PUC PROJECT NO. 56822

**AEP TEXAS INC.'S RESPONSE TO COMMISSION STAFF'S
FIRST REQUEST FOR INFORMATION**

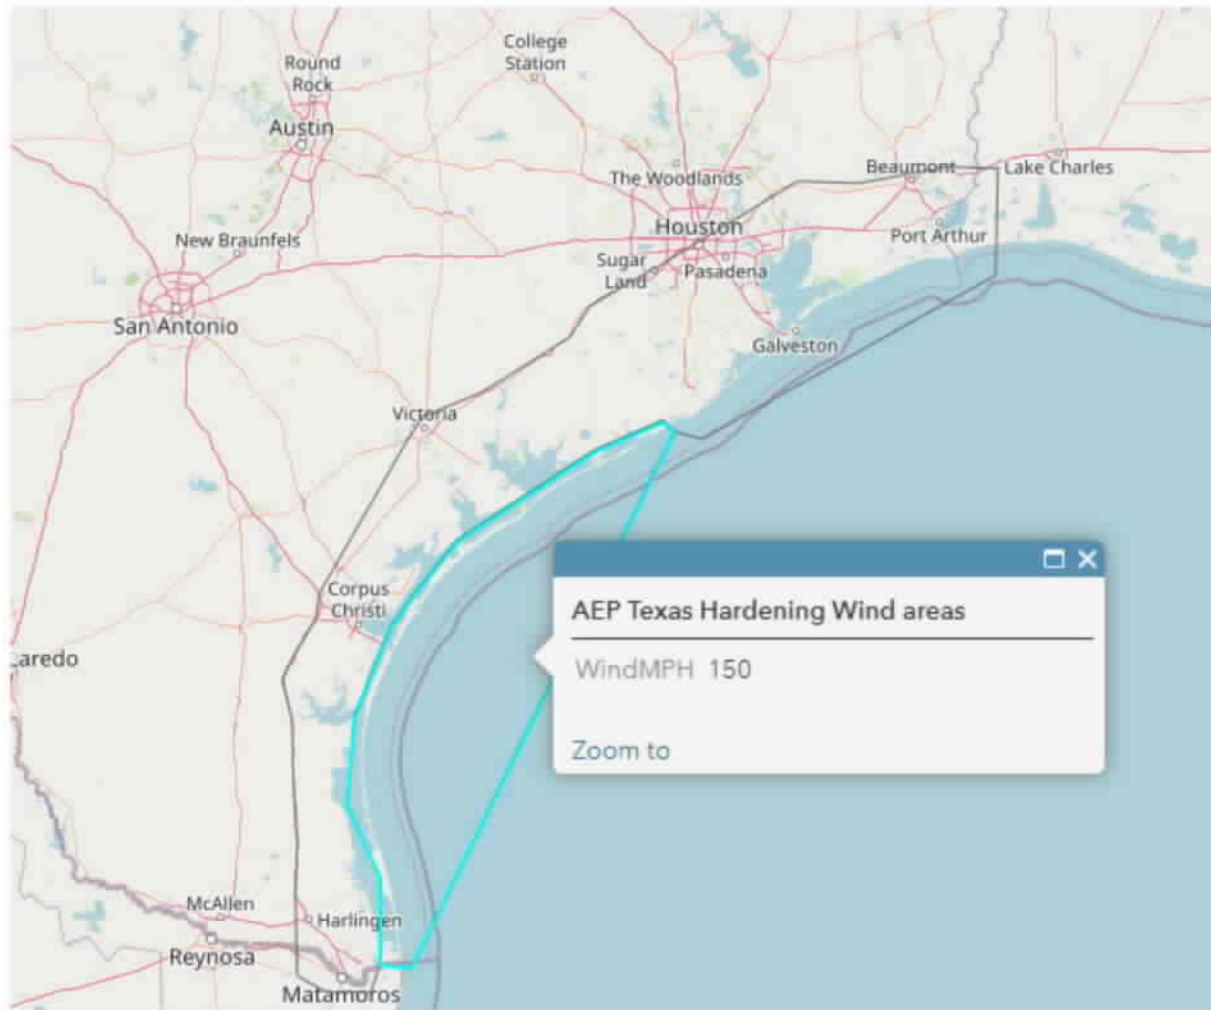
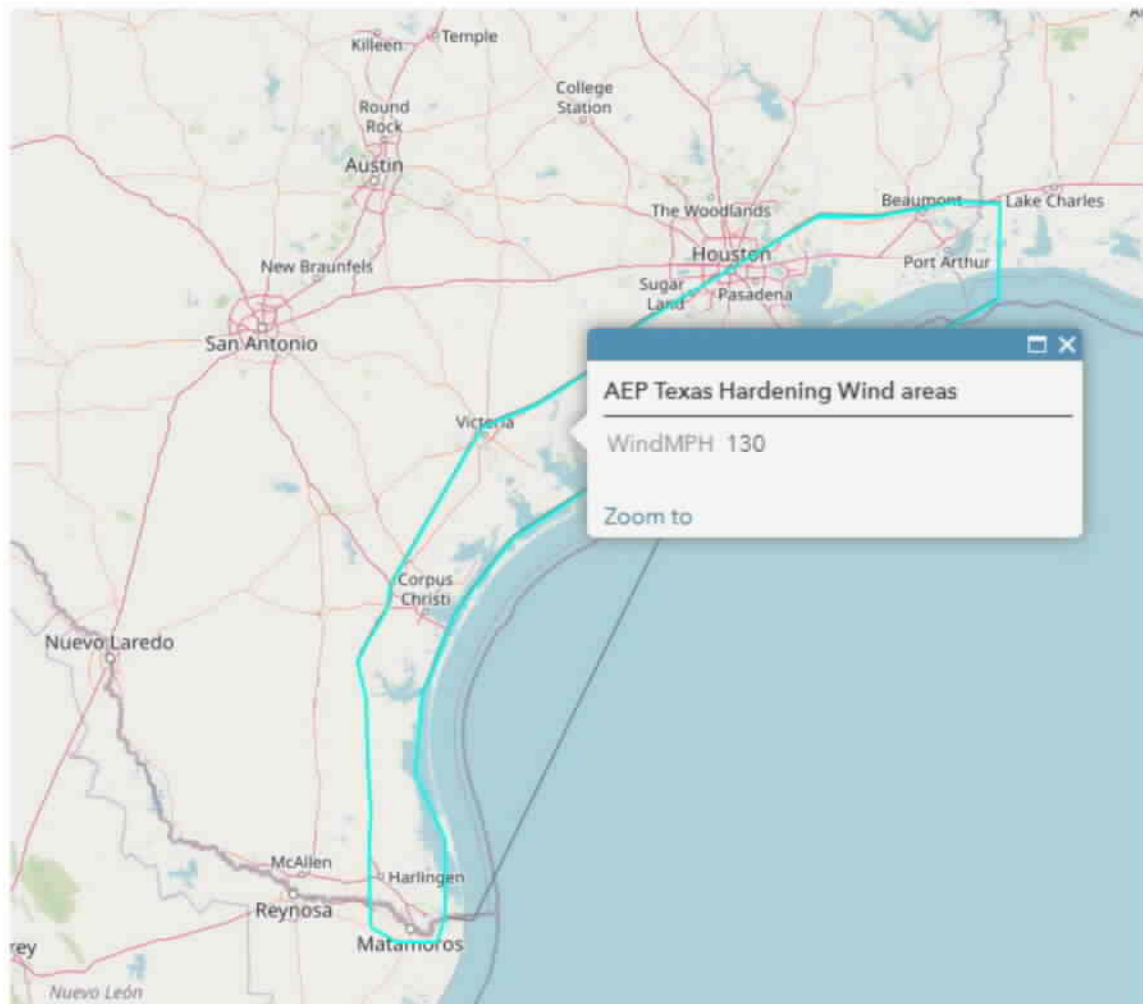
Please explain any new NESC construction strength and overload factors you adopted for distribution lines in the last two years to improve system resiliency.

AEP Texas adopted new structural loading criteria in 2014 in an effort to make the distribution system more resilient. The details of these more resilient loading criteria are as follows:

Since 2014, AEP no longer designs any Distribution using NESC Medium Zone loading criteria. AEP only uses Heavy and Light Zone. Medium Loading criteria for NESC rule 250B uses 0.25in ice, 4lb/ft² wind at 15deg F. Heavy Loading criteria for NESC rule 250B uses 0.5in ice, 4lb/ft² wind at 0deg F. The additional ice and colder temperature applied more vertical, transverse, and longitudinal load to the structure for the same given conductors and span lengths.

In the Heavy Zone, the resiliency load case of 1" ice, 4lbs/ft² wind, 0deg F using NESC Rule 250B associated strength and load factors is applied to poles, guys, and anchors. The other conductor supporting components are designed to NESC Heavy Zone requirements. This makes the pole the stronger component in the structure and ideally the last element to fail as it is the hardest element of the structure to replace.

In the Light Zone (non-coastal), the resiliency load case of 0 ice, 20lb/ft² wind, 30deg F using NESC Rule 250B associated strength and load factors is applied to poles, guys, and anchors. The other conductor supporting components are designed to NESC Light Zone requirements. This makes the pole the stronger component in the structure and ideally the last element to fail as it is the hardest element of the structure to replace. The NESC Light Loading Zone uses 0 ice, 9lb/ft² wind at 30deg F. The additional wind load for AEP Light Zone resiliency load case increases the longitudinal tension and significantly more transverse loading the poles.
